**CITY OF CASCADE LOCKS
PLANNING COMMISSION
AGENDA**

CITY OF CASCADE LOCKS
Staff Report – Summary of Findings and Recommended NOD
August 29, 2019

Application File Number: LU 19-005

Type of Action Requested: Site Plan Review

Figure 1: Split Zoning of Subject Parcel

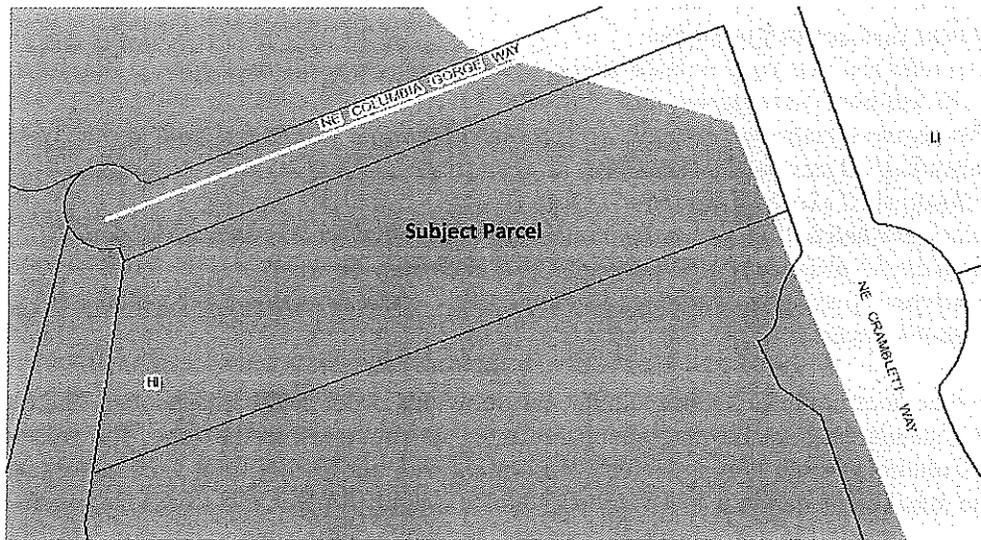
Finding: The subject parcel is split-zoned into two separate zoning districts: Light Industrial (LI) and Heavy Industrial (HI) (see Figure 1 below). The LI zone only covers a minor portion of the parcel on the northeast and eastern edge. According to the submitted site plan, no work is proposed in the LI zone with all of the proposed site improvements and building located within the HI zone. The CDC does specify how split-zoned parcels are interpreted, but as all improvements are proposed in the HI zone, LI zone standards are not addressed below.

SITE PLAN
SCALE: 1" = 40'

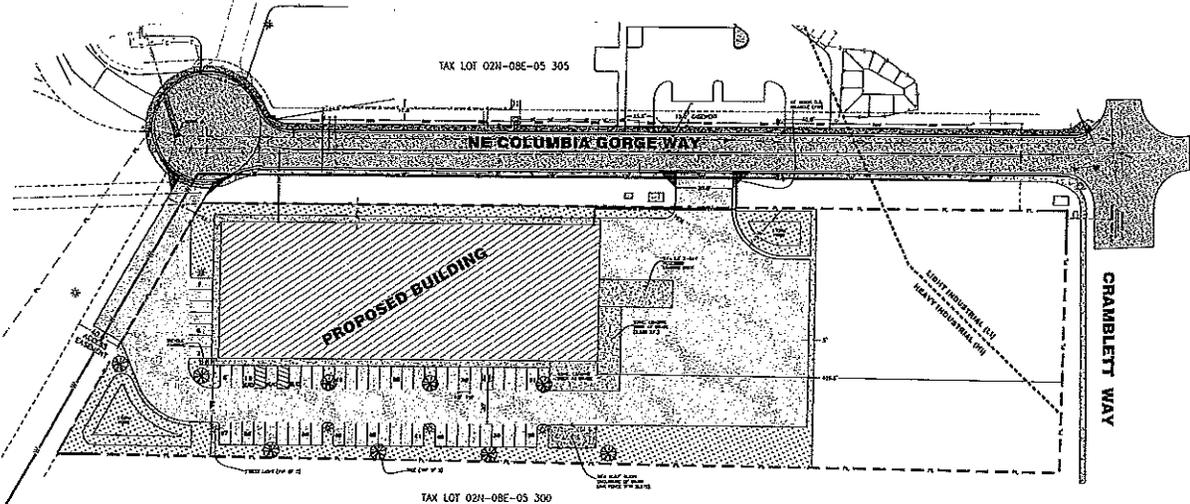
Finding: The proposed parking area is located south of the proposed building with some stalls located along the western façade of the building. Views from NE Columbia Gorge Way are effectively screened by the building. The southern parking lot is roughly 430 feet west of NE Cramblett Way. The site plan proposes four trees along the southern lot line, screening some of the views of the parking lot from the lot to the south To the west of the stalls along the western façade of the building is a 40-foot-wide public access/utility easement located on a vacant parcel (Lot 6), owned by the Port of Cascade Locks, where a new 28-foot-wide site access is proposed. The applicant is proposing nine parking area trees, including within landscape islands and along the southern lot line, which meets the one tree per seven parking spaces standard as 57 spaces are proposed. Three of the landscape islands along the

southern parking area do not contain any trees, according to the site plan. All landscape islands meet the minimum dimensional standard.

Finding: The applicant is proposing 90 degree parking spaces. Per the submitted site plan, stall widths are ten feet, aisle width is 30 feet and stall lengths are 20 feet. This standard is met.

Finding: The applicant is proposing parking spaces along the western frontage of the building that could potentially conflict with the proposed western access to the site. The applicant has been conditioned to go through engineering review prior to building permit approval to confirm that there will be no backing movement or other conflicts at this access point. The site would be accessed off of NE Columbia Gorge Way, which currently terminates at the northwest portion of the site via roundabout with an outer edge of 40 feet, according to the site plan.

Finding: As shown on the site plan, 15-foot vision clearance triangles are included at each driveway connecting to NE Columbia Gorge Way. This standard is met.

As a **Condition of Approval**, the landscape strip along the southern parking lot, between the parking lot and the southern lot line, shall utilize special design features, such as shrubs, a hedge, or a landscaped berm, to effectively screen the parking lot from the lot to the south. The type of screening shall be specified on the landscape plan.

As a **Condition of Approval**, the landscape plan shall include and the site plan shall be updated to include one tree planted in each landscape island.

As a **Condition of Approval**, the site plan shall be updated to include a direct pedestrian connection between the proposed walkway along the northern frontage of the building and the existing sidewalks along NE Columbia Gorge Way prior to building permit approval.

CONCEPTUAL GRADING/STORMWATER
SCALE: 1" = 40'

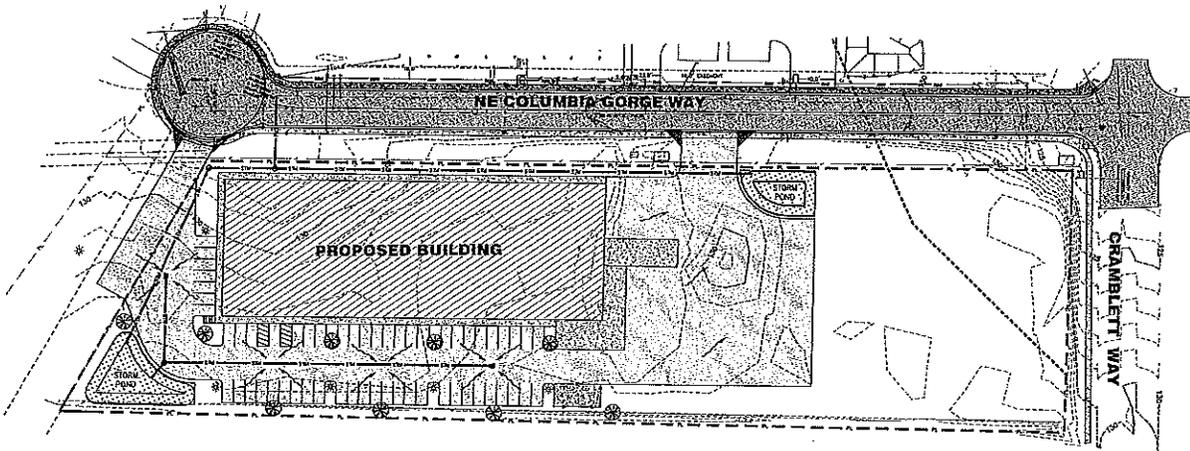
Finding: According to the conceptual grading and stormwater plan, parking and loading areas will drain to two stormwater ponds proposed on the northeast and southwest corners of the site. Water will not flow to public sidewalks or streets. This standard is met.

Finding: The applicant submitted a grading and stormwater plan drawn by a registered engineer that includes the aforementioned information. The applicant has been conditioned to provide erosion control techniques during construction and also for the proposed grading and erosion control activities to go through engineering review prior to building permit issuance.
